### World Forum for Harmonization of Vehicle Regulations

## **Proposal for Amendment 3 to UN Global Technical Regulation No. 9 (Pedestrian Protection)**

### **Submitted by the Working Party on Passive Safety\*, \*\***

"Figure 6A

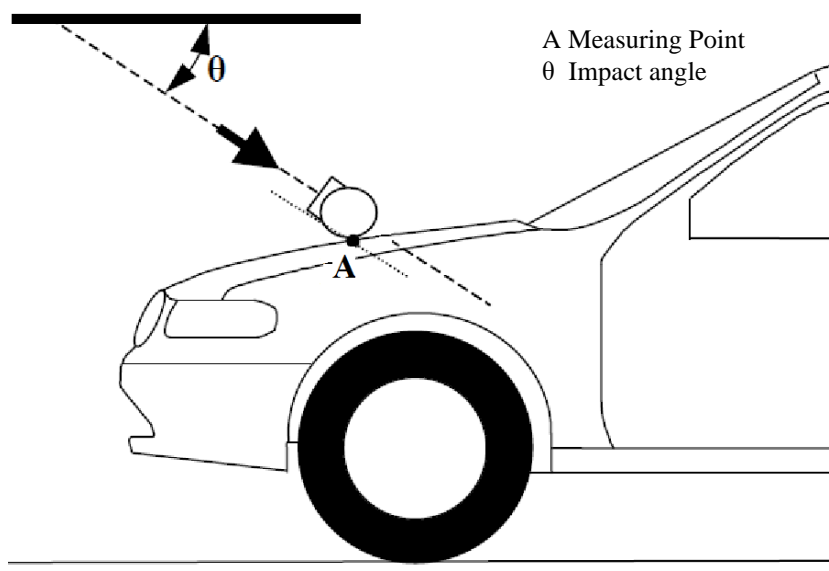
Figure 6, shall be deleted

Insert new Figures 6A and 6B, to read:

**Measuring point in the vertical longitudinal plane through the centre of the headform impactor (see paragraph 3.21.1) <sup>1</sup>**

<sup>1</sup> Note: due to the spatial geometry of the bonnet top, the first contact may not occur in the same vertical longitudinal or transverse plane which contains measuring point A.

- 3.21.1. "Measuring point" for the headform test means a point on the vehicle's outer surface selected for assessment. The measuring point is where the headform's profile contacts the vehicle's outer surface cross section in a vertical longitudinal plane through the center of gravity of the headform (see Figure 6A).
- 3.21.2. "Measuring point" for the lower legform to bumper test and the upper legform to bumper test is located in the vertical longitudinal plane through the central axis of the impactor (see Figure 6B)."

"Figure 11

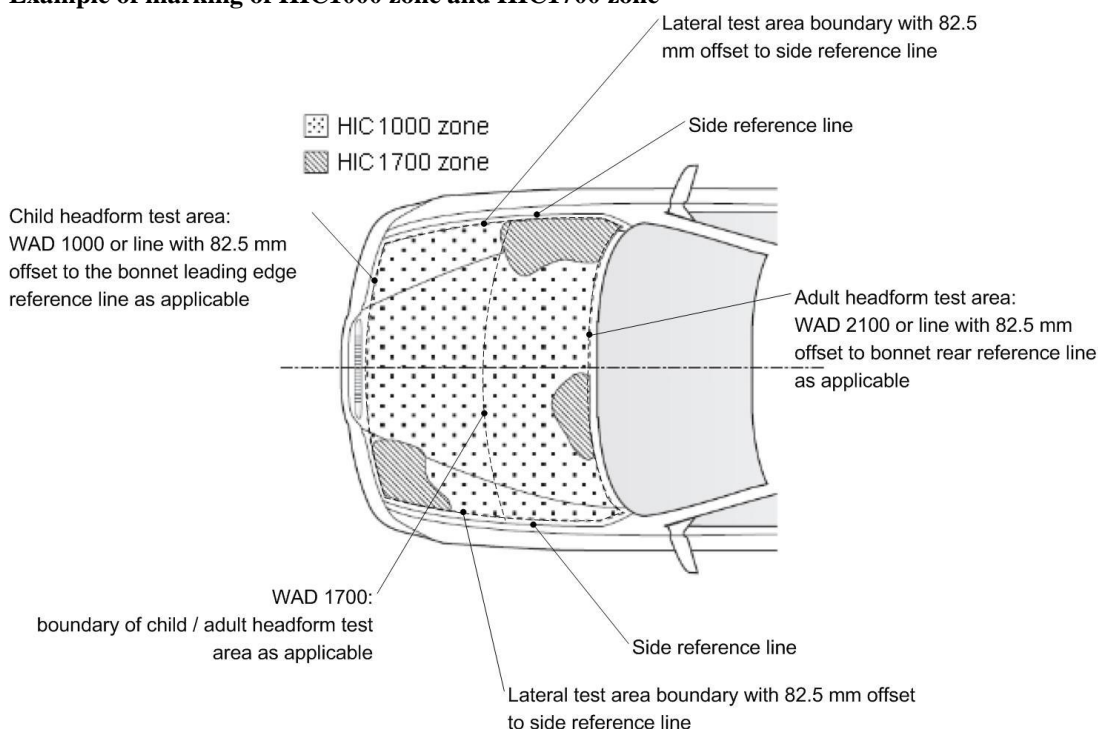
Figure 11(former), shall be deleted

Insert new Figure 11, to read:

**Example of marking of HIC1000 zone and HIC1700 zone**

"5.2.4.1. The manufacturer shall identify the zones of the bonnet top test area where the HIC must not exceed 1,000 (HIC1000 Zone) or 1,700 (HIC1700 Zone) (see Figure 11)."
